November 20, 2018

**Re: McDonalds - 8315 Montgomery Blvd NE
Tract A-1-F of the Los Pastores Shopping Center
Grading and Drainage Plan - Engineer's Stamp dated: missing (F19D013A)**

RE: 8315 Montgomery Blvd. NE – HYDROLOGY COMMENTS

PRE-DEVELOPED DRAINAGE PLAN

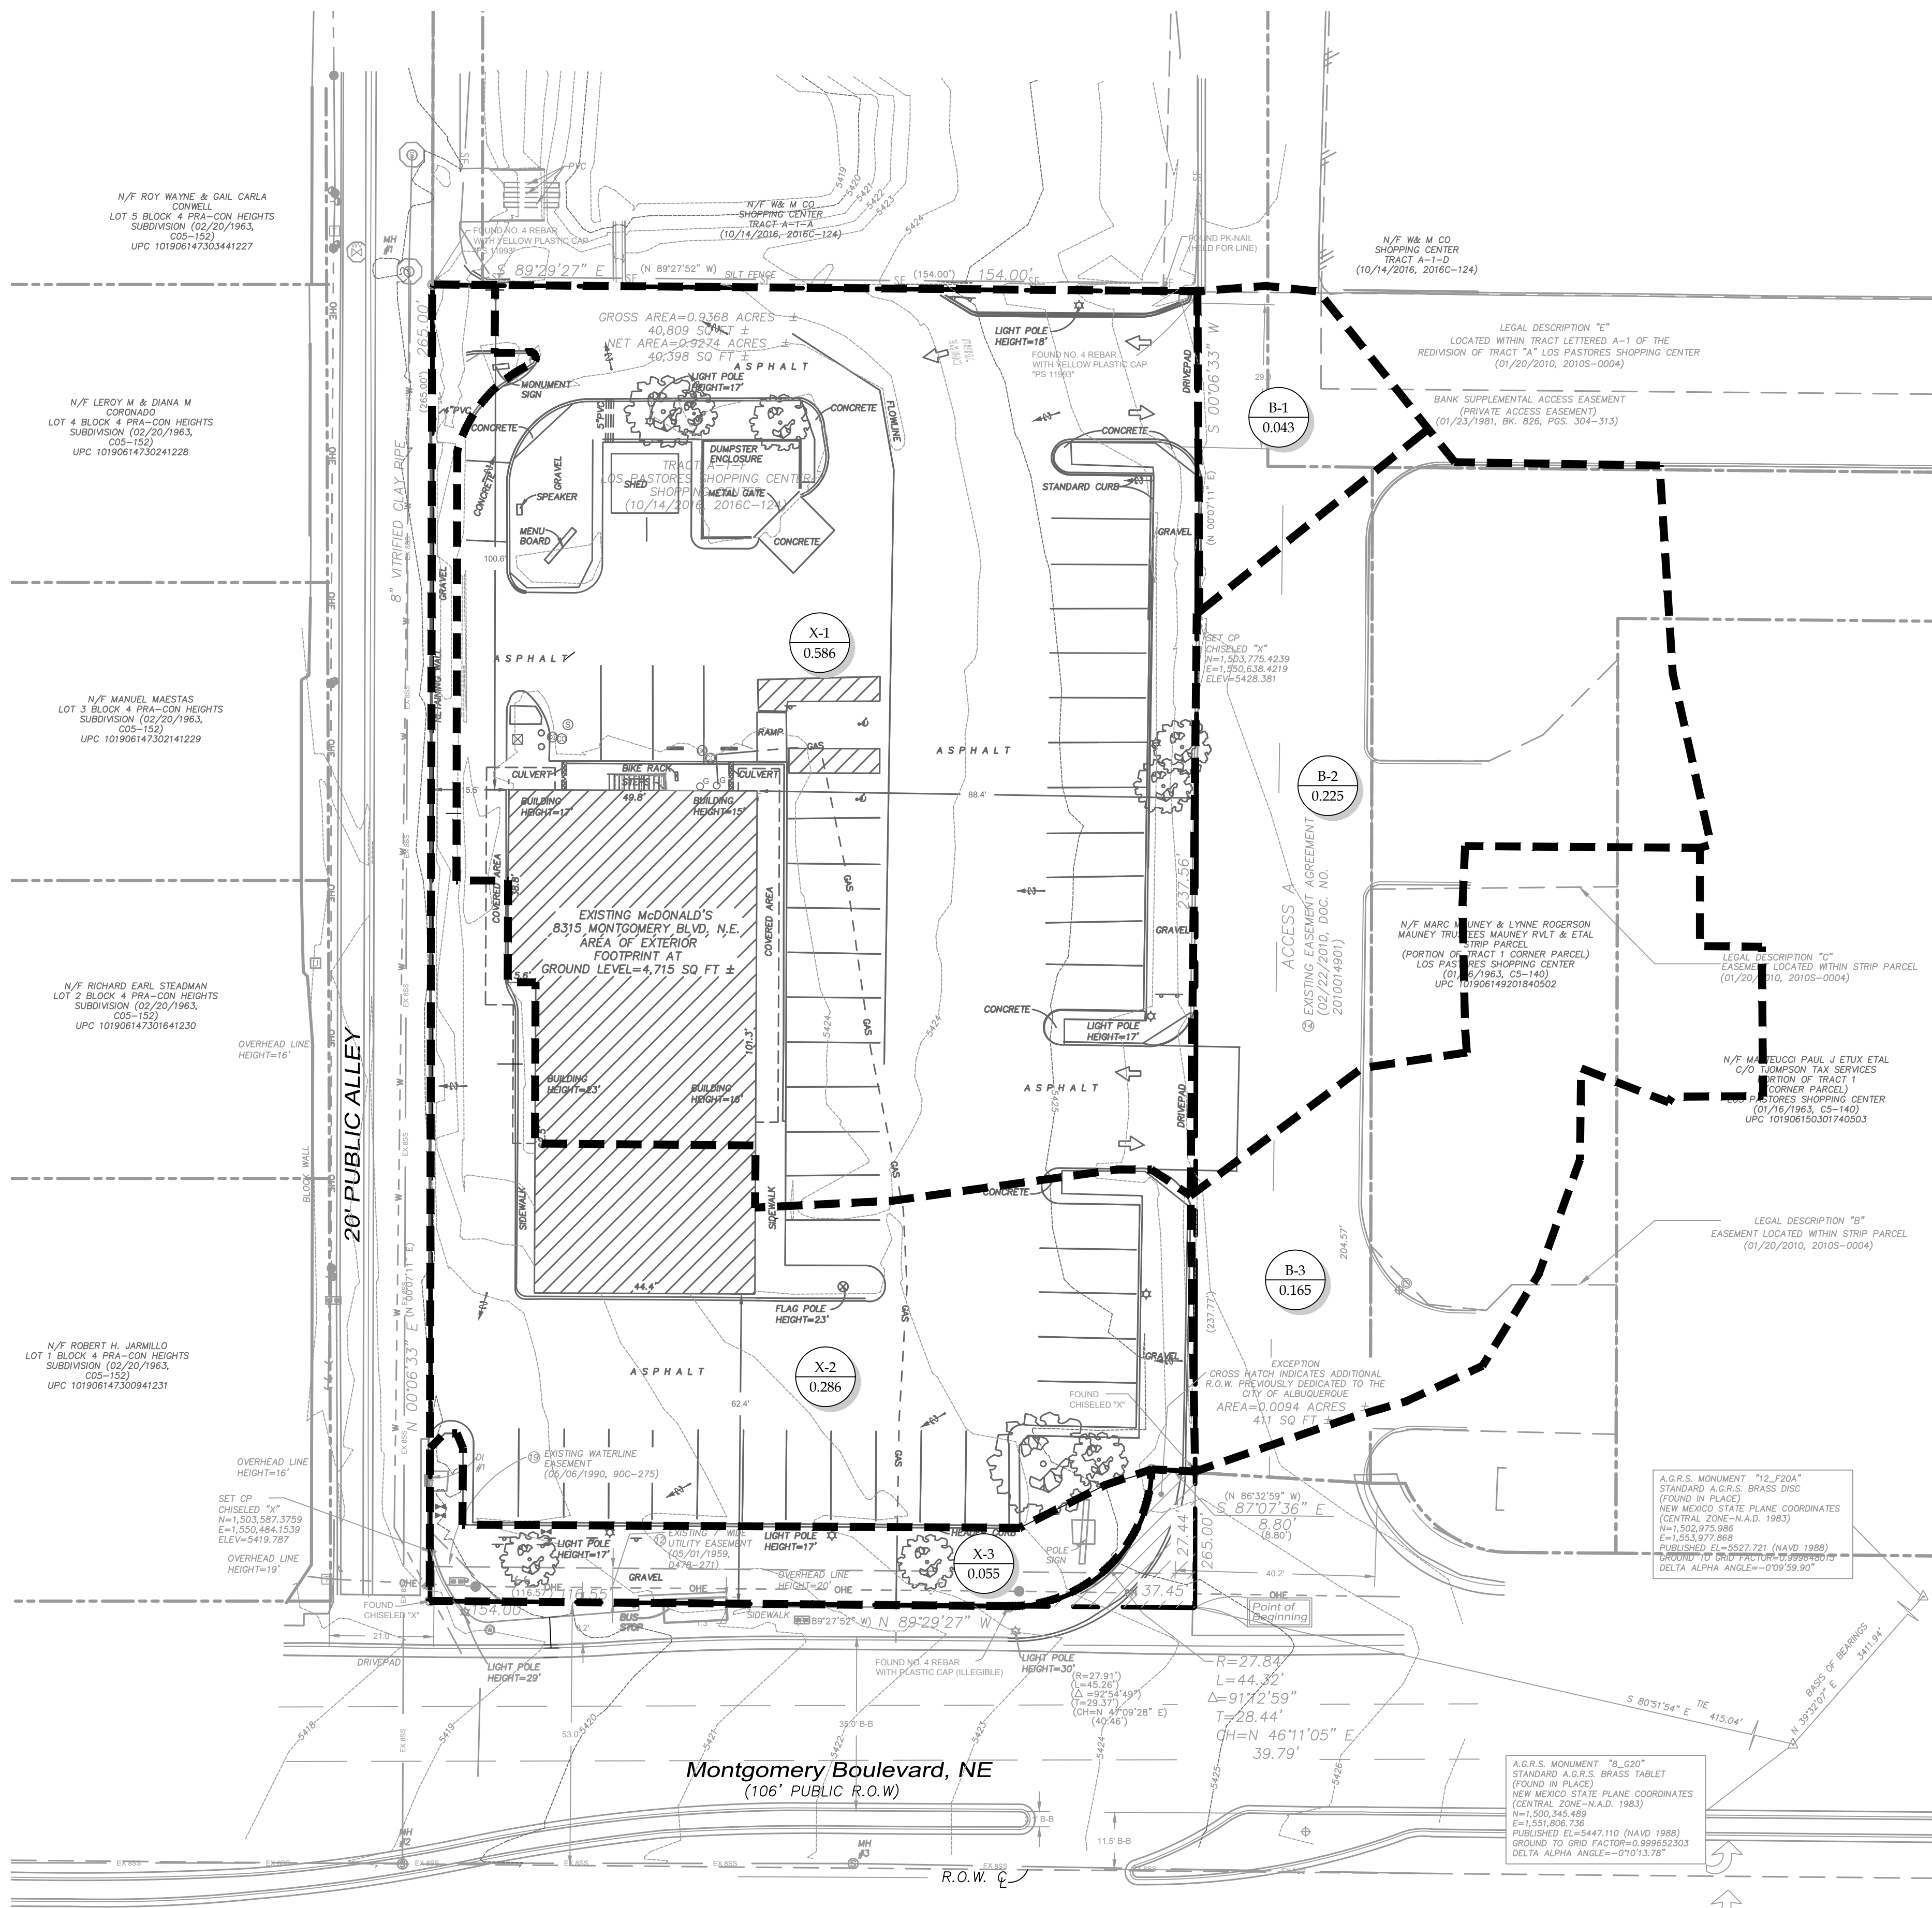
- 6) The proposed development plan for the McDonalds must either conform to the previously approved Drainage Management Plan for Tract A-1-F of the Los Pastores Shopping Center or a revised plan is required to determine new peak flow rates in the alley west of McDonalds and in Montgomery Blvd. using AHYMO instead of the simplified 100 year 6 hour runoff calculations in tables on sheets 8.0 and 8.2. If the proposed development plan is revised to conform to the previously approved Drainage Management Plan then the tables on sheets 8.0 and 8.2 must state the runoff rates and volumes associated with land treatments A, B, C, and D. **Flows from the McDonald's site do not worsen the alley drainage or pond drainage (and design point flows have been added to C8.1 for reference). To conform to previously approved Drainage Management Plan, Sheets C8.0 and C8.2 show the runoff rates and volumes associated with land treatments A, B, C, and D.**

EXISTING CONDITIONS: REFER TO SHEET C8.0 FOR THE PRE-DEVELOPED DRAINAGE PLAN FOR THIS SITE. STORMWATER RUNOFF GENERALLY DRAINS NORTHWARD TOWARDS THE DETENTION POND OR SOUTHWEST ACROSS THE SITE UNDER EXISTING CONDITIONS. SHEET C8.0 IDENTIFIES SIX DRAINAGE DIVIDES FOR THIS SITE. AREA X-1 CONSISTS OF 586 ACRES FLOWING OFFSITE TO THE DETENTION POND, AREA X-2 CONTAINS 0.286 ACRES DRAINING SOUTHWEST TO THE ADJACENT ALLEY, AND AREA X-3 CONTAINS 0.055 ACRES DRAINAGE SOUTH TO MONTGOMERY BLVD. OFFSITE AREAS B-1 (0.043 AC) AND B-2 (0.225 AC) DRAIN ONTO X-1. AREA B-3 (0.165) DRAINS ONTO X-2. PEAK DISCHARGE RATE AND RUNOFF VOLUME CALCULATIONS FOR EXISTING CONDITIONS ARE PROVIDED ON SHEET C8.0.

POST-DEVELOPED DRAINAGE PLAN

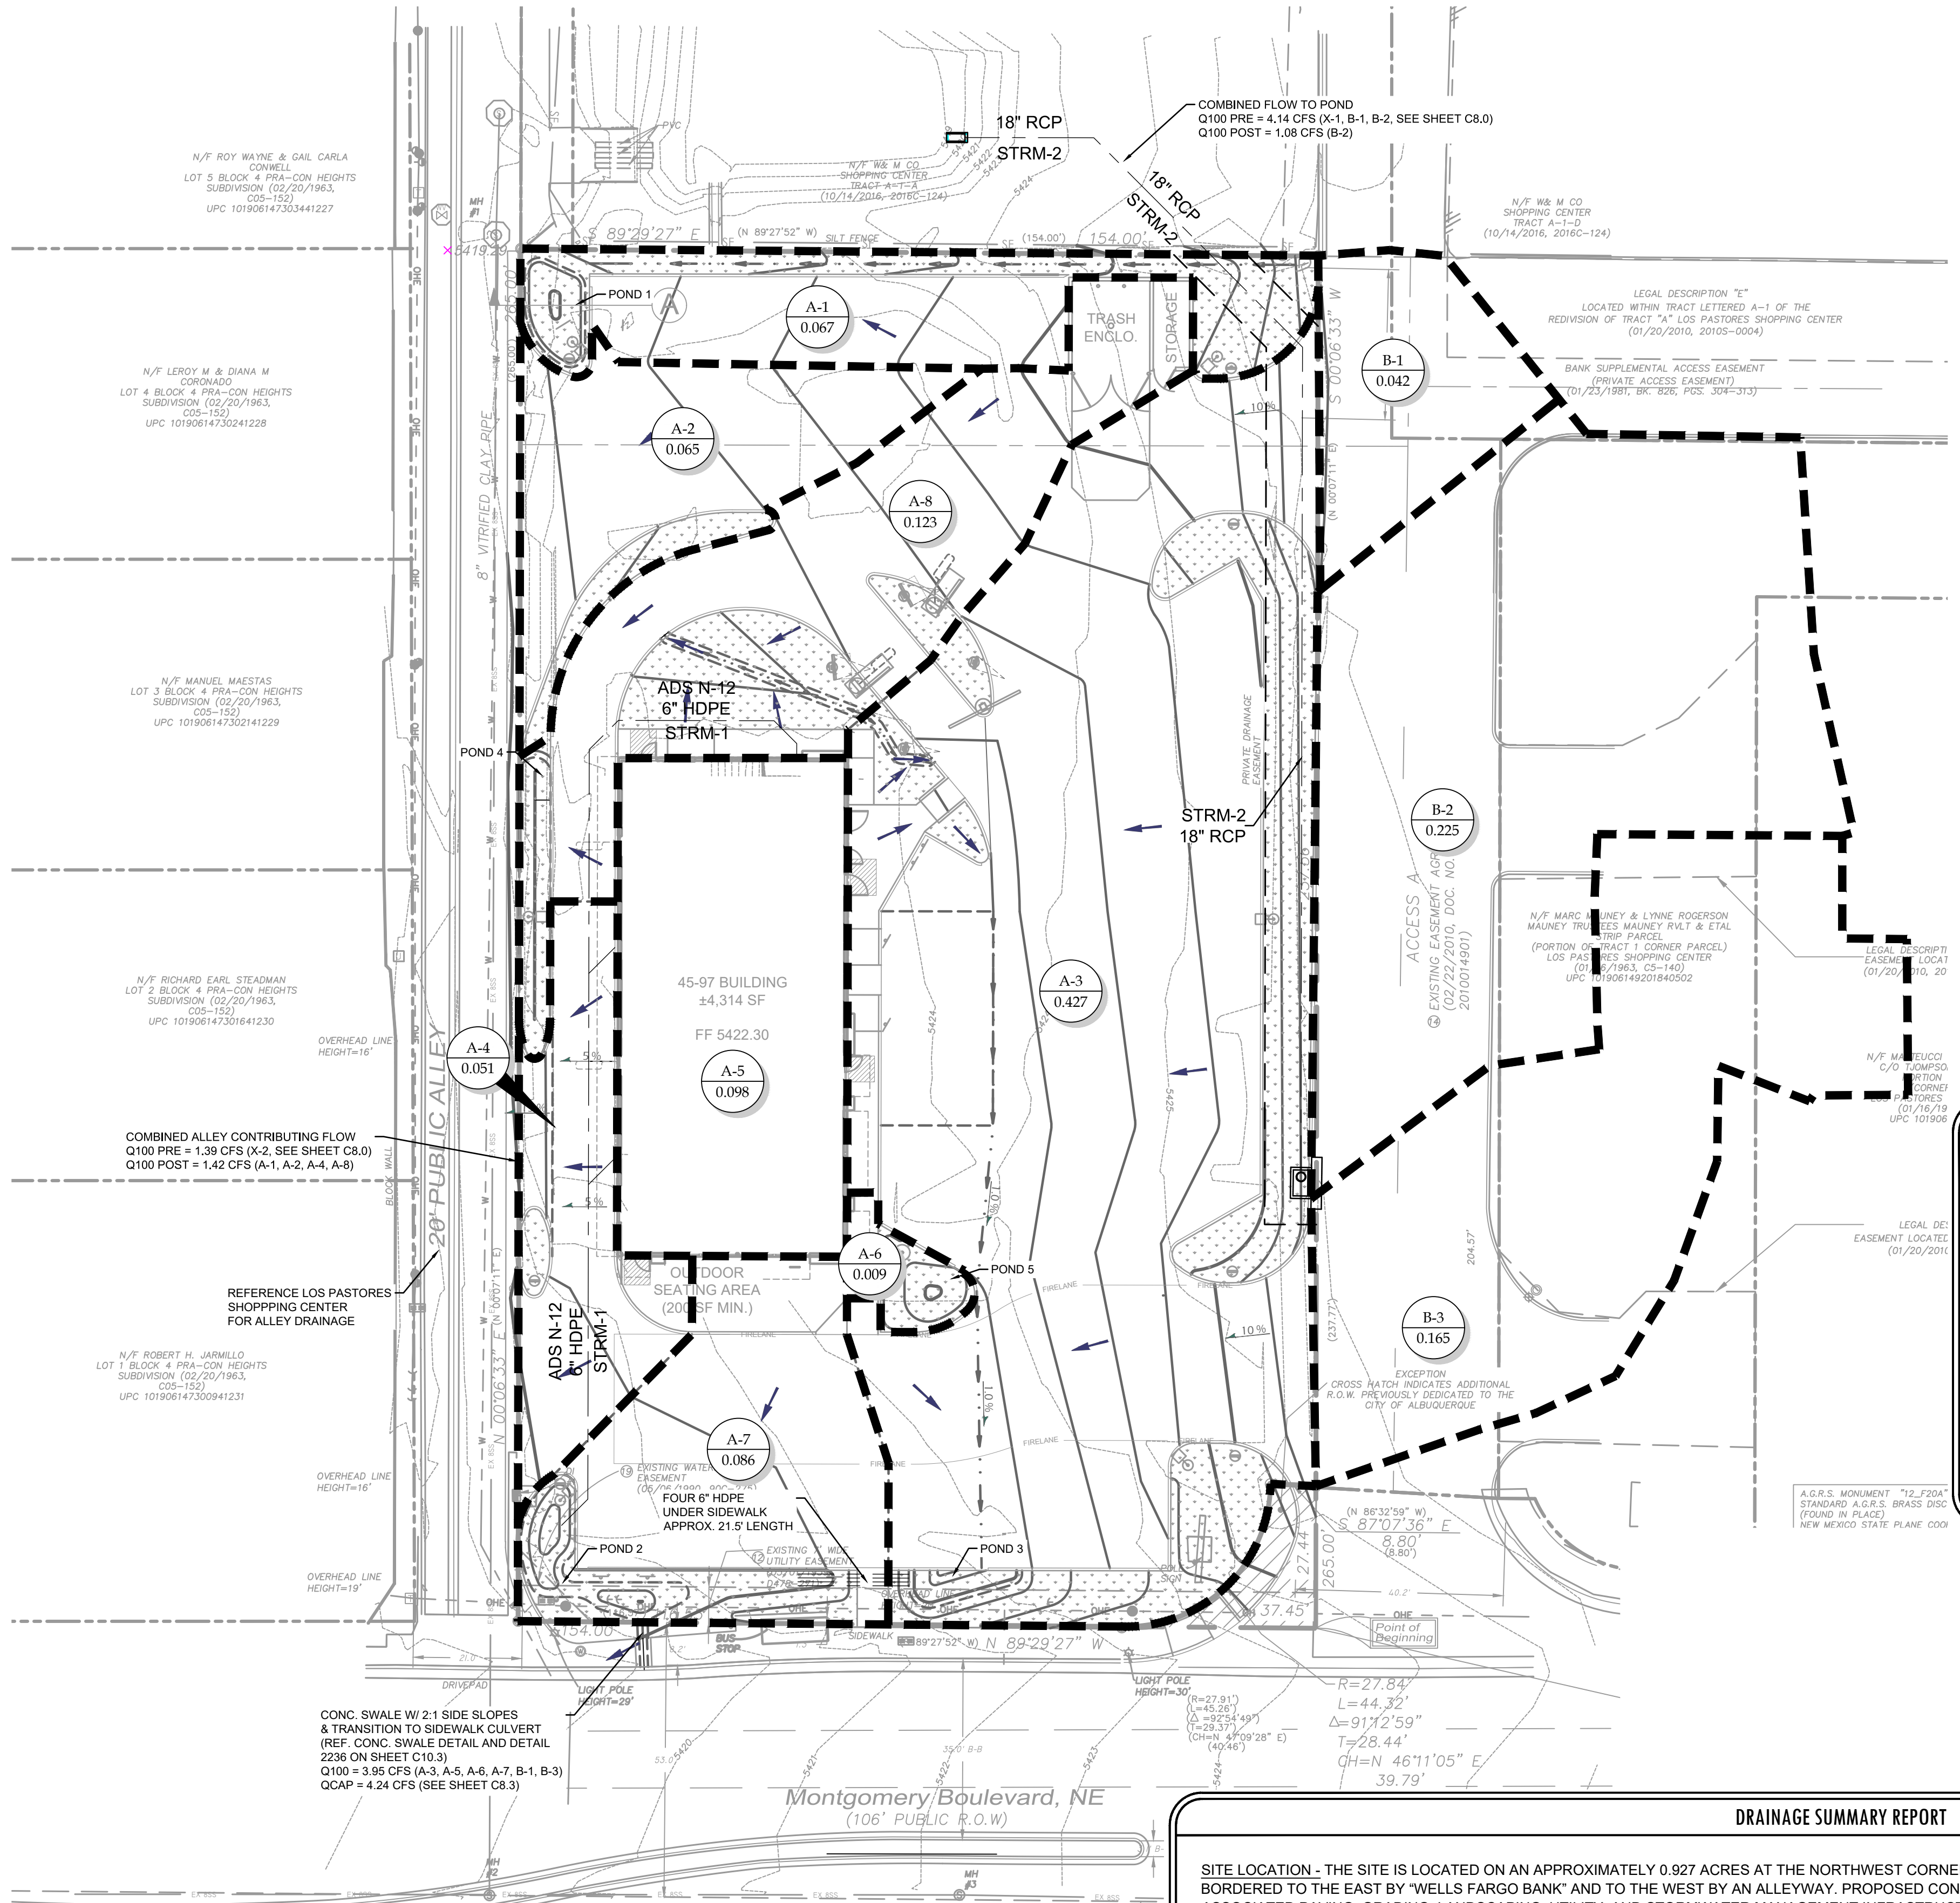
6. The drainage management summary on sheet 8.1 needs to be revised to include discussion of the diversion of flow from the Los Pastores Pond and the limited capacity downstream of this site in the alley and in Montgomery. The narrative should acknowledge the Drainage Management Plan for the Los Pastores Shopping Center and discuss specifically how the proposed site will conform to that plan. This level of analysis, hydrograph development, pond routing, and detailed hydraulic analysis is more easily bound into a report than spread out on 24" x 36" sheets, but either way the calculations must be stamped and signed by a registered Professional Engineer in the state of New Mexico.

- 7) The drainage summary on sheet 8.1 says basin A-1 drains into the offsite detention pond but there is not sufficient detail to see how that drainage enters the pond. Instead it appears that the drainage enters Pond 1. A typical section is required thru the north and west boundary in association with Basin A-1 and Pond 1. The sections must include horizontal and vertical dimensions to the property line and show both existing and proposed grade. **Basin A-1 currently is not proposed to drain to the offsite detention pond, but it drains to Pond 1. Pond 1 overflows via depressed curb to the alley. A section of Pond 1 is shown on Sheet C8.2 and spillway calculations are shown on sheet C8.3.**

- 12) Existing Spot elevations are not legible. The minimum font size is 0.10". Dots show up instead of text around the perimeter of the site. The drainage summary on sheet 8.1 also has dots instead of text. **Text heights were increased to 0.10"**

PROPOSED CONDITIONS: REFER TO SHEET C8.1 FOR THE POST-DEVELOPED DRAINAGE PLAN. ELEVEN DRAINAGE BASINS ARE IDENTIFIED UNDER PROPOSED CONDITIONS. AREA A-1 (0.067 AC) DRAINS INTO POND 1 AND ULTIMATELY TO THE ALLEY TO THE WEST. AREAS A-5 (0.098 AC), A-6 (0.009 AC), A-7 (0.086 AC), AND A-8 (0.123 AC) ALL FILTER THROUGH FIRST FLUSH POUNDS BEFORE FLOWING OFFSITE. REFER TO SHEET C8.1 TO SEE THE DRAINAGE BASINS AND CORRESPONDING FIRST FLUSH POUNDS. AREA B-1 (0.042 AC) AND B-3 (0.165 AC) DRAIN ONTO A-3, THEN FLOW PASSES TO FIRST FLUSH POND 3. THEN TO POND 2 AND ULTIMATELY TO MONTGOMERY BLVD. N.E. AREA B-2 (0.225 AC) IS CAPTURED BY CURB INLET AND IS PIPED DIRECTLY TO THE OFFSITE DETENTION POND. THE TOTAL SITE GENERATED FLOW OF 4.39 CFS AT THE 100-YEAR STORM EVENT IS LESS THAN THE EXISTING FLOW OF 4.44 CFS. TOTAL REQUIRED FIRST FLUSH VOLUME (0.28") IS 716 CUBIC FEET WITH AN OVERALL TOTAL PROPOSED STORAGE OF 442 CUBIC FEET.
